**C**onversion  
of Filter Presses to  
Vacuum Filter Dryers  
at VEAS

Arbitration Report

Title Conversion of Filter Presses to Vacuum Filter Dryers at VEAS Arbitration Report	Serial No. 3916-98	Date 1998.08.21
	Report No. Sub-No. O-98138	Pages Price
Author(s) Damhaug, Torbjørn	Topic group 30 Avløpsteknologi	Distribution
	Geographical area Norge	Printed NIVA

Client(s) Vestfjordens Avløpsselskap VEAS	Client ref. 51.400-291.98 22.07.98
----------------------------------------------	------------------------------------------

### DRAWING # 2

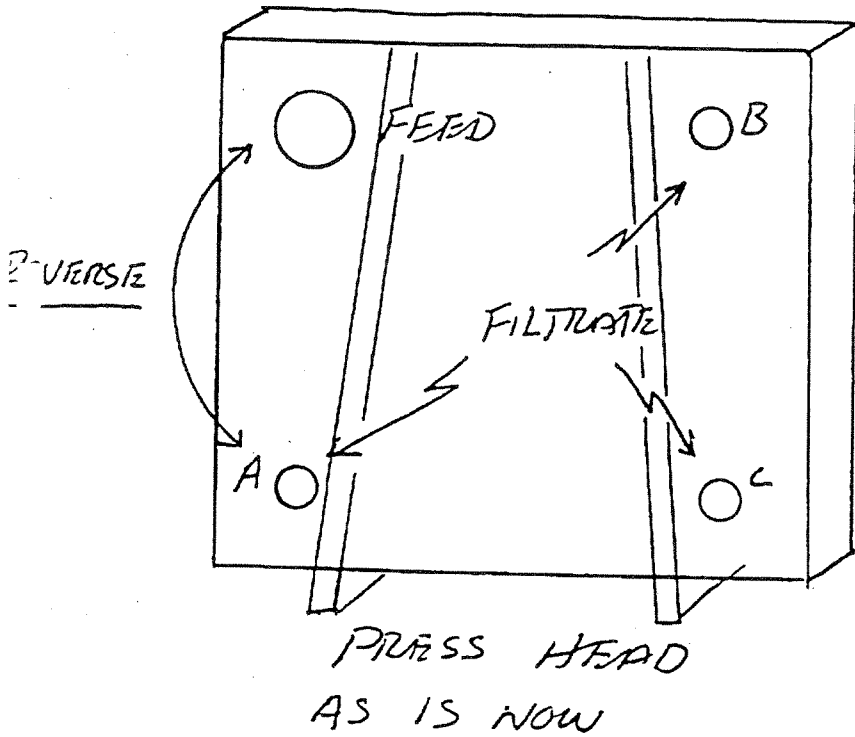
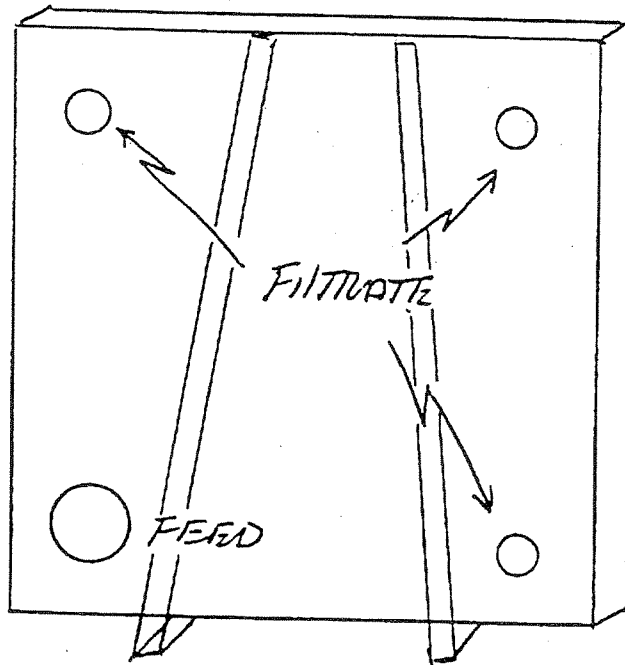
The feed line needs to be moved to the filtrate hole directly below it (see drawing #2). The plastic liner plate must be turned 90 degrees to accommodate the feed line (see drawing #3). The changes to the liner plate and feed line can be started by the B.B. personnel before we arrive.

FEED LINE NEEDS TO BE WHERE FILTRATE "A" IS NOW

FILTRATE LINE "A" GOES TO FEED LINE.

FILTRATE LINE "B" + "C" REMAIN THE SAME.

### DRAWING #3

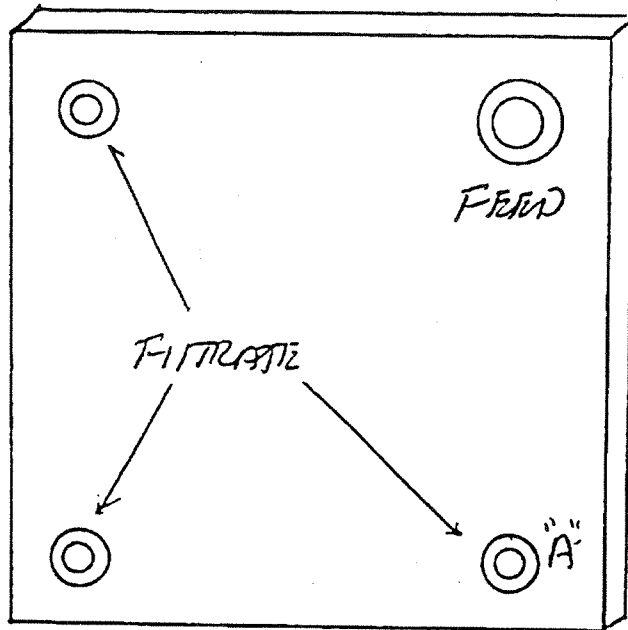
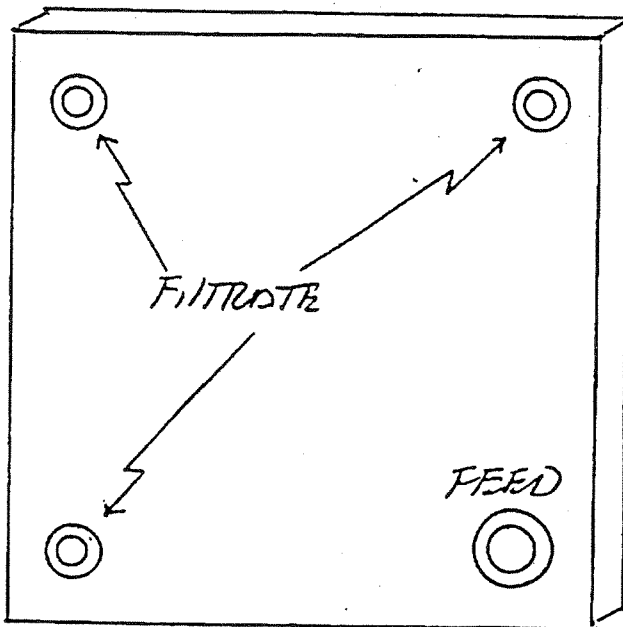
ROTATE LINER PLATE  
SO FEED LINE IS  
AT FILTRATE  
POSITION "A"

## DIAGRAM FOR HANGER EXTENSIONS

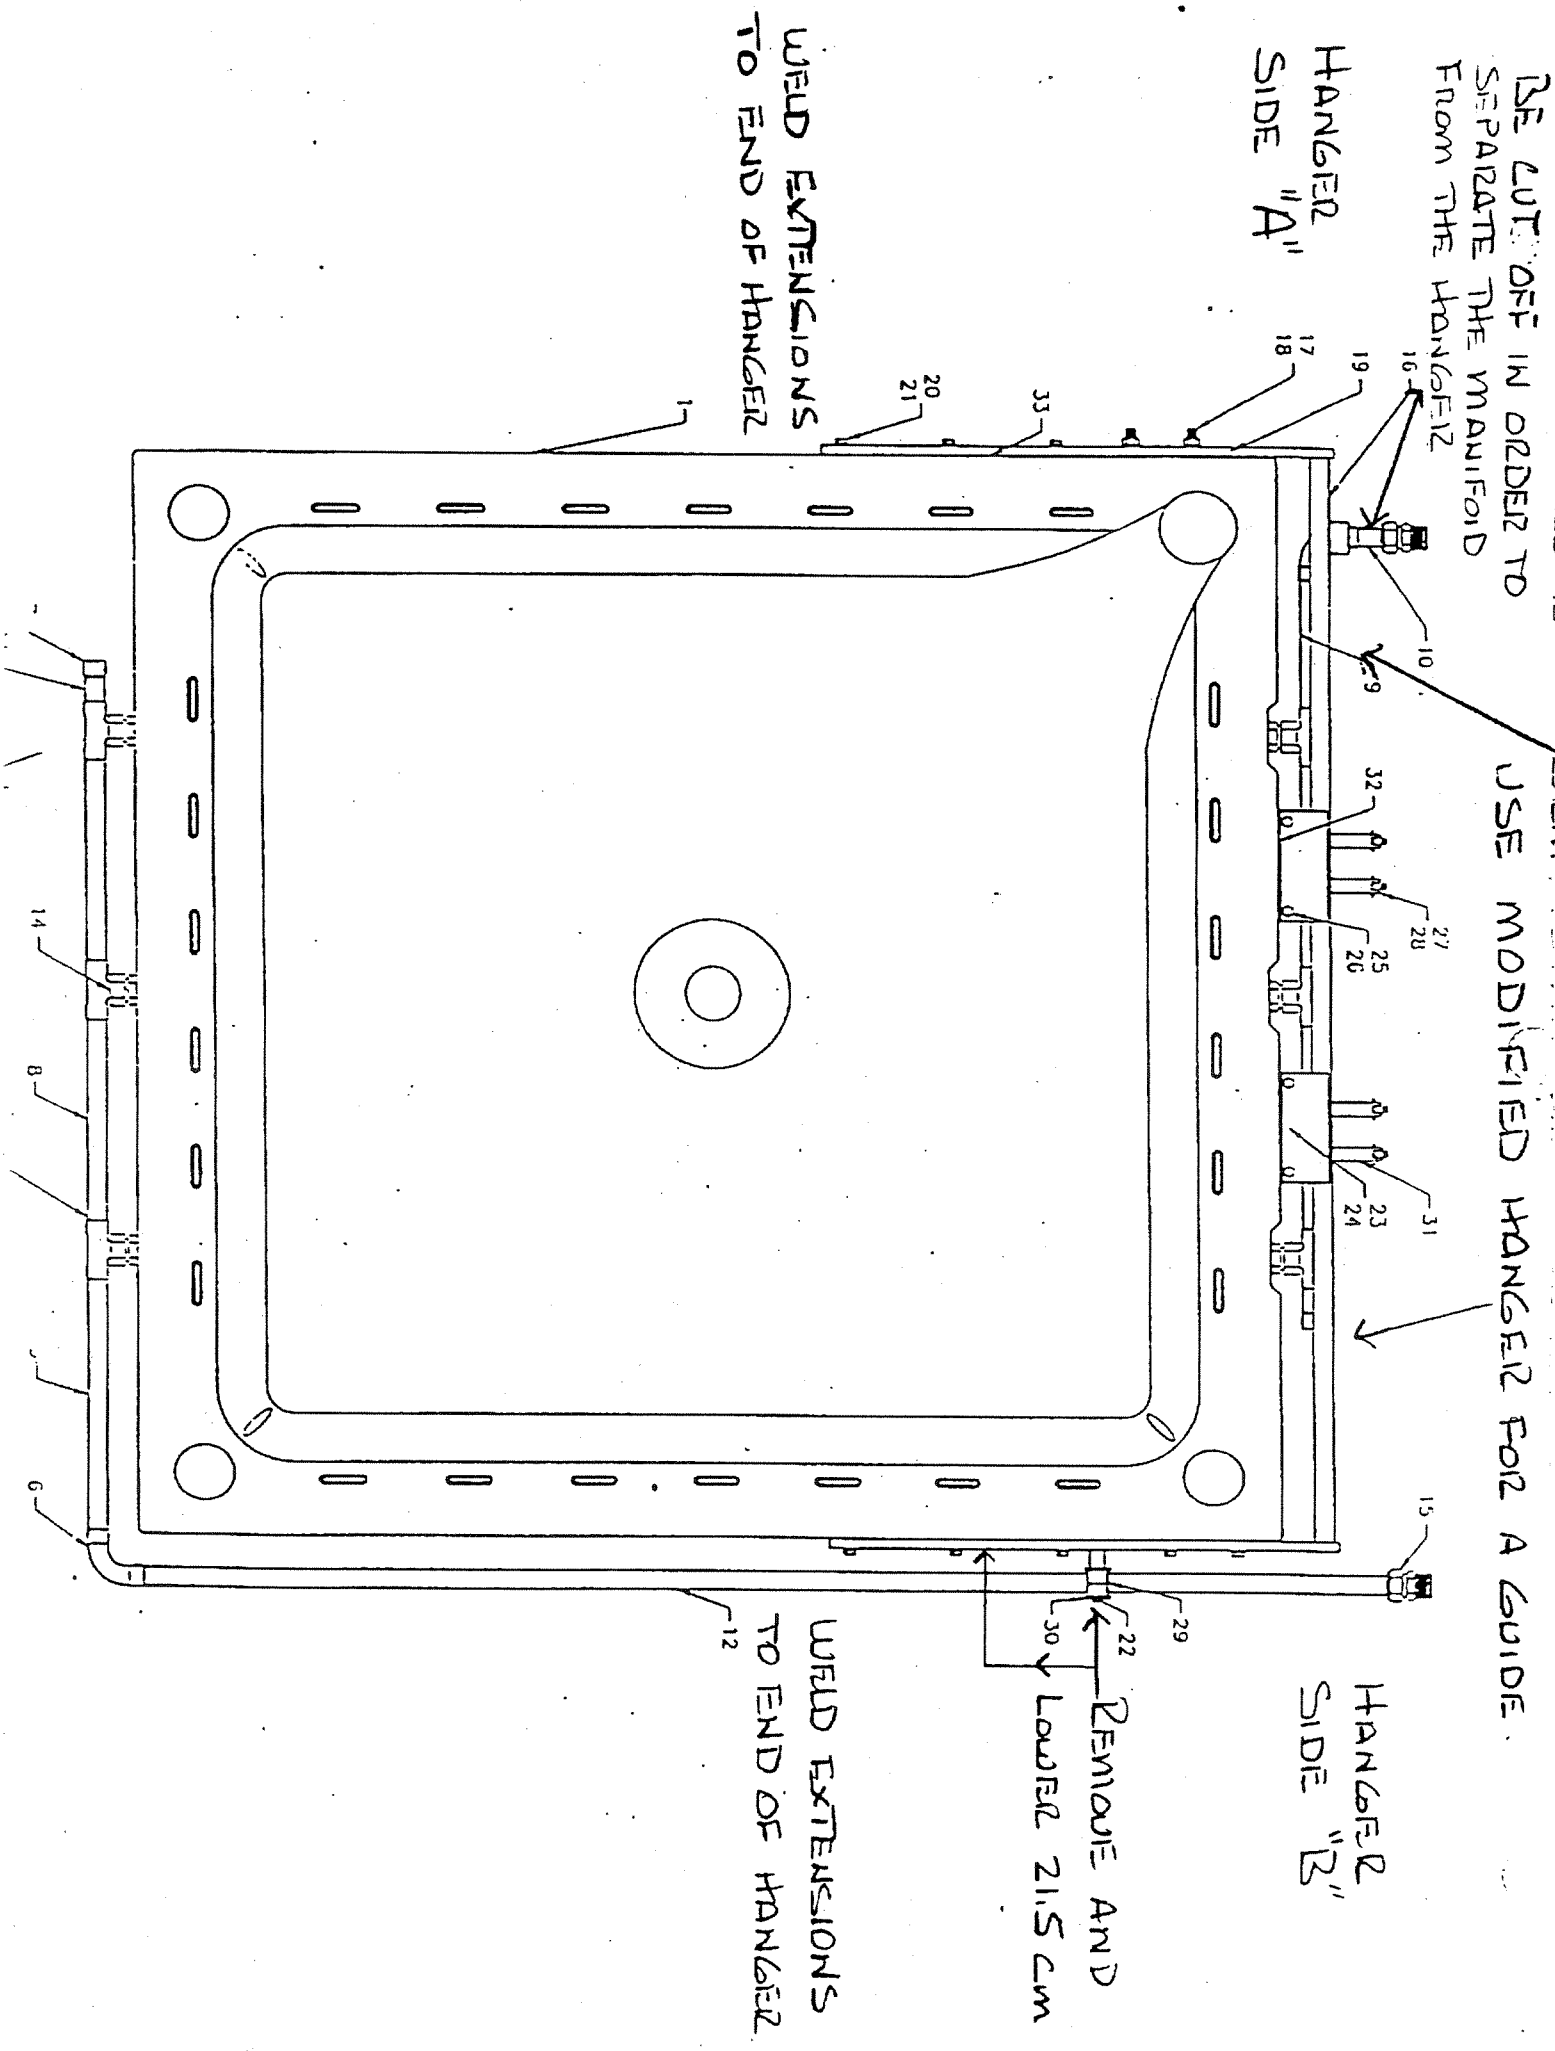
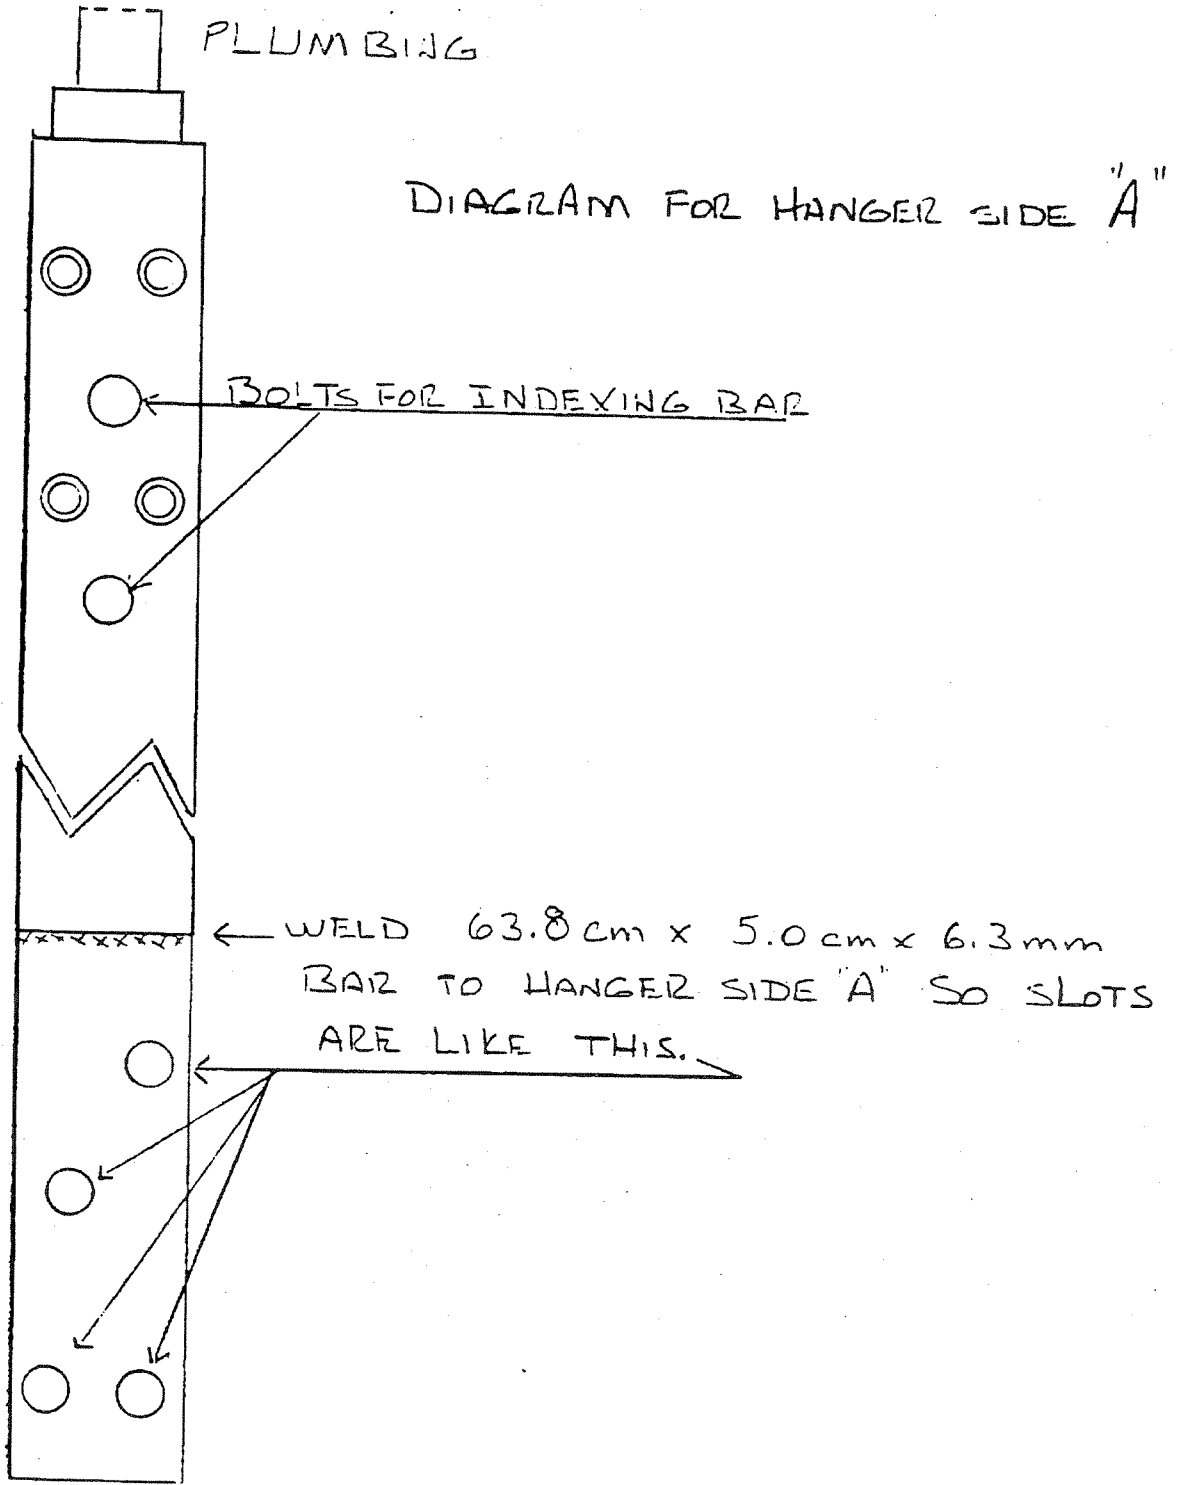
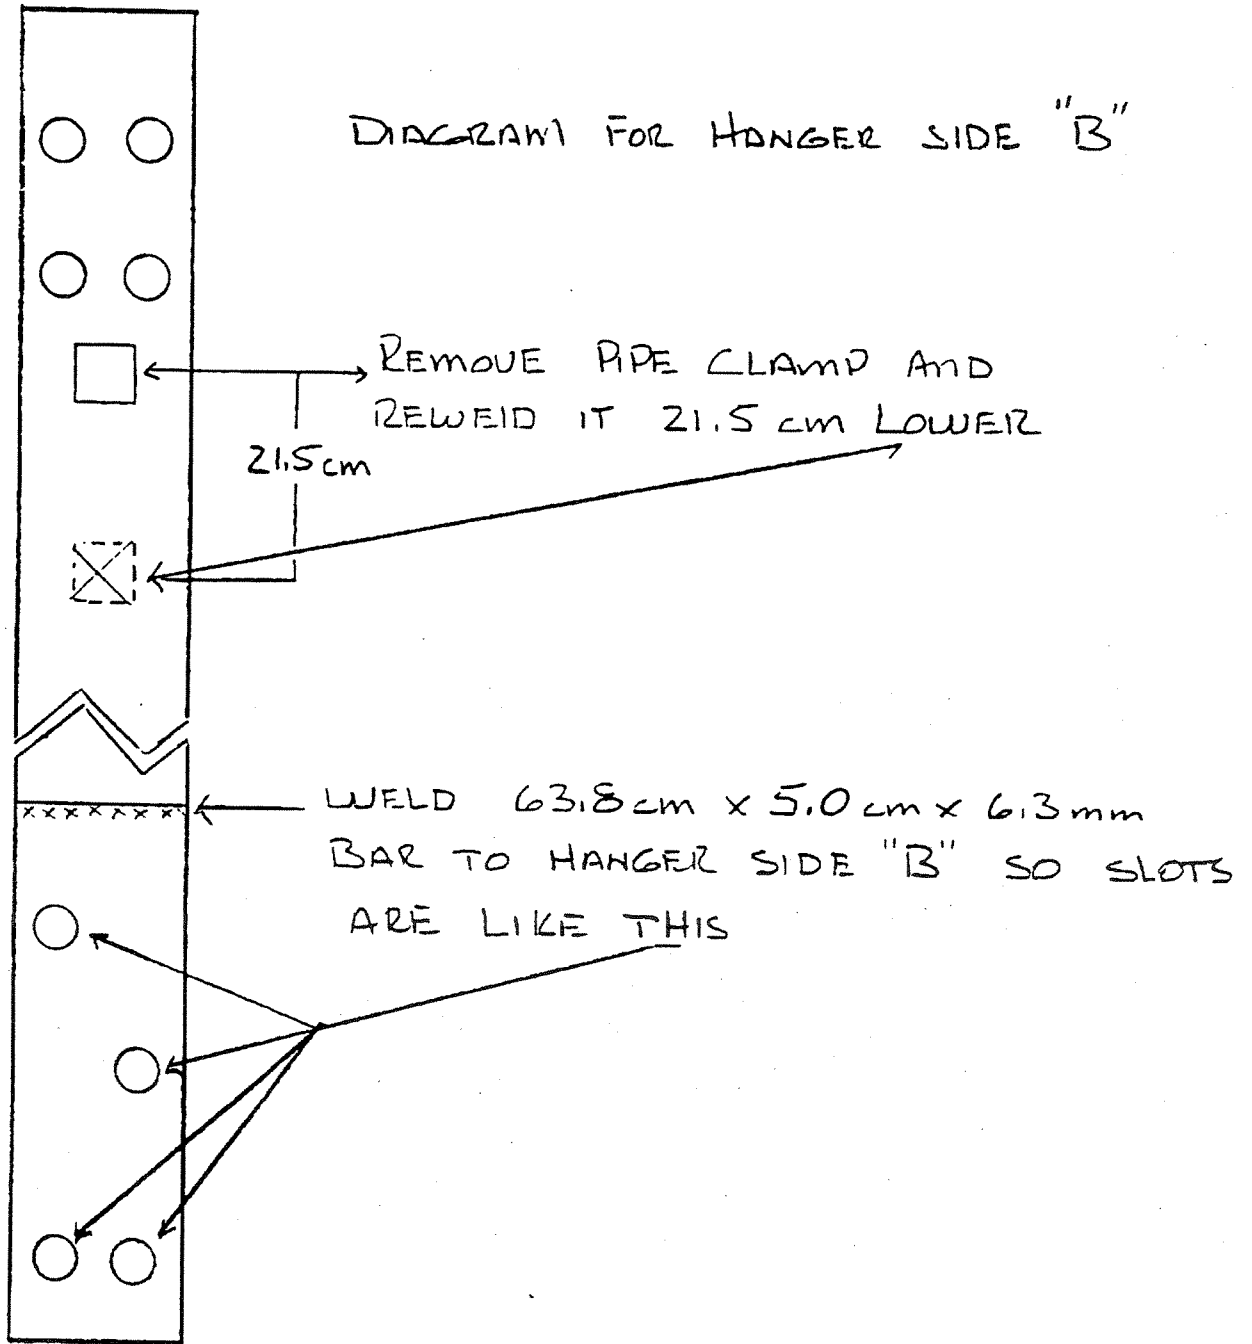
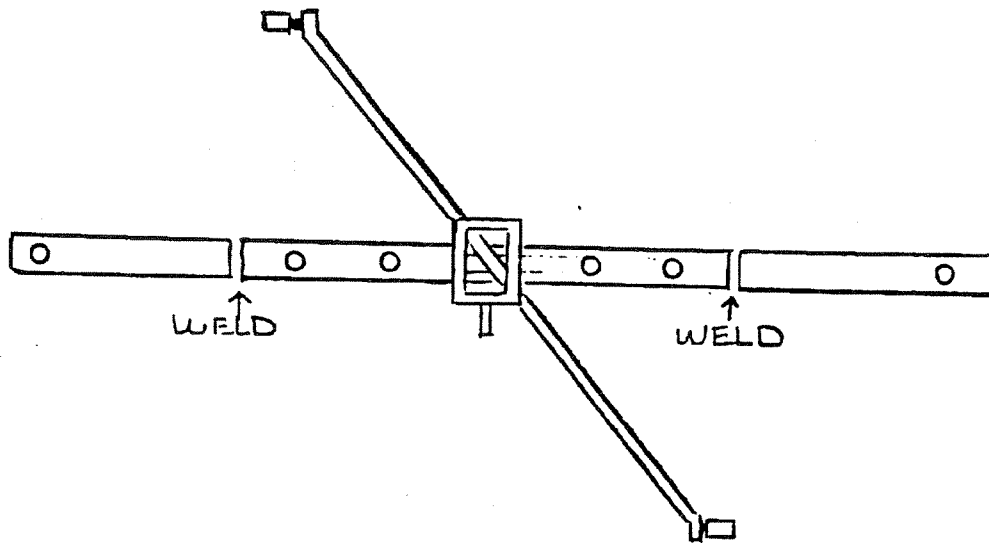
WELD EXTENSIONS TO END OF HANGER

REMOVE AND LOWER 21.5 CM

WELD 35.56 cm x 4.44 cm x 4.44 cm  
SQUARE TUBING ROLLER EXTENSIONS ON  
THE END OF THE ROLLERS AS SHOWN.

10 mm HOLES WILL NEED TO BE DRILLED  
IN THE TOP OF THE HANGER FOR THE  
NEW HOLES AT THE END OF THE EXTENSIONS,  
USE THE MODIFIED HANGER AS A  
GUIDE FOR THESE NEW HOLES.
